Product Change Notification

Product group:	< SKiiP3 >	Rev.:	00
No.:	PCN 13-053	< Improvement of robustness against moisture >

Subject of change: SKiiP3 isolation foil power module

Description of change:	 old isolation foil	 new isolation foil
	Old version: isolation foil from HOSTAPHAN RN 25	New version: isolation foil from PI FEP

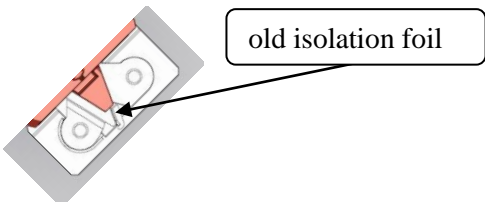
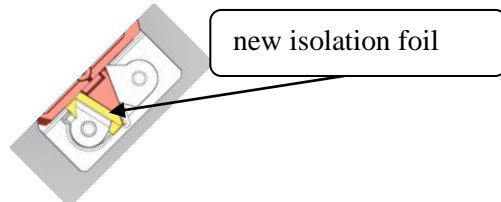
Replacement of isolation foil and improvement of internal bus bars for a more robust design against moisture. Nevertheless climate class 3K3 will not change.

Reason for change: More robust against moisture

Old and new versions are fully compatible to each other (paralleling possible).
